TI_2402: Omission of the centre cover of the installation area at the rear.

iVario 2-XS & iVario Pro
2-S

26/02/2024

Component	Article number
Centre cover rear installation area	12.02.684P

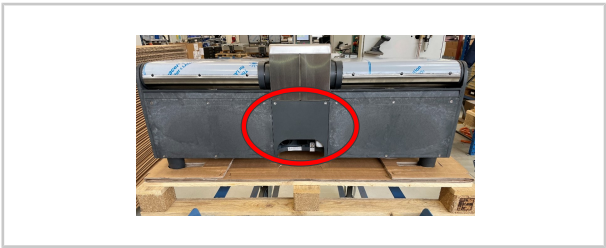
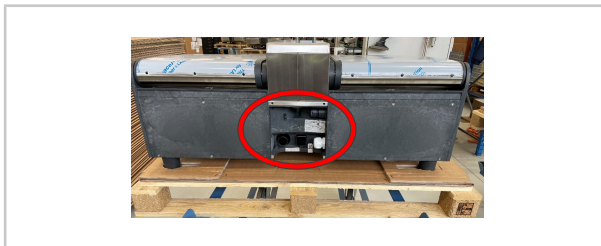
The centre cover for the rear installation area is omitted for series production and is no longer installed.

The centre cover for the rear installation area will no longer be installed from 15/02/2024.

This improves the air flow and reduces the temperature in this area. The centre cover is therefore not part of the unit.

The cover for the rear installation area Art. no.: 12.02.684P is no longer available as a replacement part and has been given the status "No longer available, without replacement".
